Contract #: 04-0120F4Cty: SF/ALA Rte: 80 PM: 13.2/13.9File #: 69.25B**QUALITY ASSURANCE -- NON-CONFORMANCE REPORT****Location:** Changxing Island, Shanghai, P.R. China**Report No:** NCR-000820**Prime Contractor:** American Bridge/Fluor Enterprises, a JV**Date:** 29-Jul-2010**Submitting Contractor:** Zhenhua Port Machinery Company, Ltd (ZPMC), Changxing Island**NCR #:** ZPMC-0782**Type of problem:**

<b>Welding</b>	<b>Concrete</b>	<b>Other</b>	
<b>Welding</b>	<b>Curing</b>	<b>Procedural</b>	<b>Bridge No:</b> 34-0006
<b>Joint fit-up</b>	<b>Coating</b>	<b>Other</b>	<b>Component:</b> Segment 10BE DP425 U-Rib Skin
<b>Procedural</b>	<b>Procedural</b>	<b>Description:</b> Bent/Damage Component

**Reference Description:** Bent/Damage was noted on the Segment 10BE DP425 U-Rib Skin**Description of Non-Conformance:**

**Subject:** NCR No. ZPMC-0782

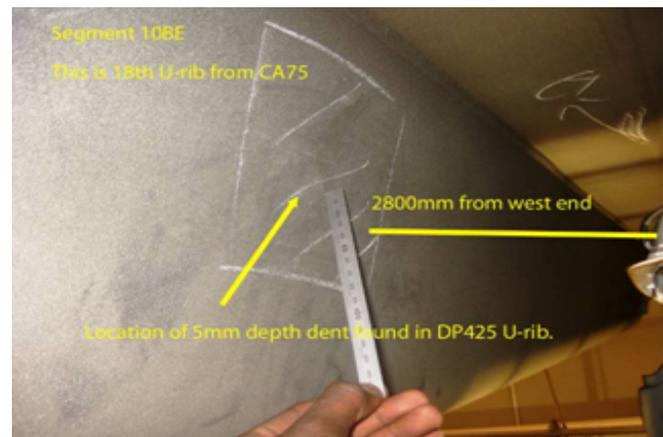
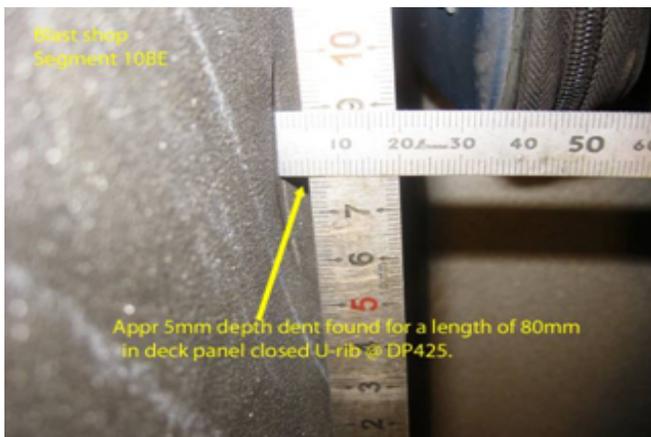
During random in-process Visual inspection of OBG Segment 10BE after Abrasive Blasting this Caltrans Quality Assurance Inspector discovered the following issue:

- Damage was observed on the U-Rib Skin.
- A bent mark of approximately 5mm in depth was measured with a 150mm ruler.
- The length of the bent mark is approximately 80mm.
- This deck panel is identified as DP425 (PL445B) and the U-rib is identified as (RS23C).
- This is 18th U-rib from the CA75.
- The location of the distortion is 2800mm away from the west end of the Segment 10BE.
- Prior to this damage, this DP was previously inspected and accepted as documented by green tag #7850.
- The OBG Segment 10BE is located inside the Paint shop#1.

Caltrans Standard Specifications Section 55-1.04: In handling of the steel work, every care shall be taken to avoid bending, scraping or overstressing the pieces. All pieces bent or otherwise injured will be rejected.

**Reference Resolution:** ZPMC has repaired the damaged area in accordance with the TC RFI and is providing the NDT after to show the repair is acceptable.

The proposed resolution is acceptable. This NCR is closed.

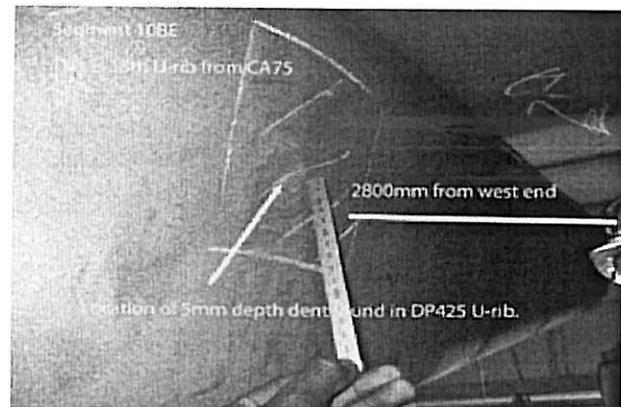
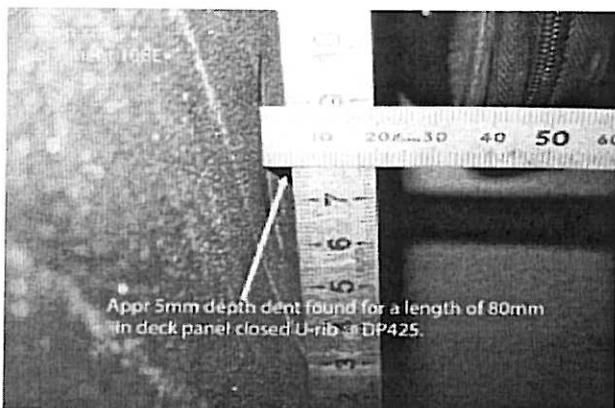
During random in-process Visual inspection of OBG Segment 10BE after Abrasive Blasting this Caltrans Quality Assurance Inspector discovered the following issue:

- Damage was observed on the U-Rib Skin.
- A bent mark of approximately 5mm in depth was measured with a 150mm ruler.
- The length of the bent mark is approximately 80mm.
- This deck panel is identified as DP425 (PL445B) and the U-rib is identified as (RS23C).
- This is 18th U-rib from the CA75.
- The location of the distortion is 2800mm away from the west end of the Segment 10BE.
- Prior to this damage, this DP was previously inspected and accepted as documented by green tag #7850.
- The OBG Segment 10BE is located inside the Paint shop#1.

Caltrans Standard Specifications Section 55-1.04: In handling of the steel work, every care shall be taken to avoid bending, scraping or overstressing the pieces. All pieces bent or otherwise injured will be rejected.
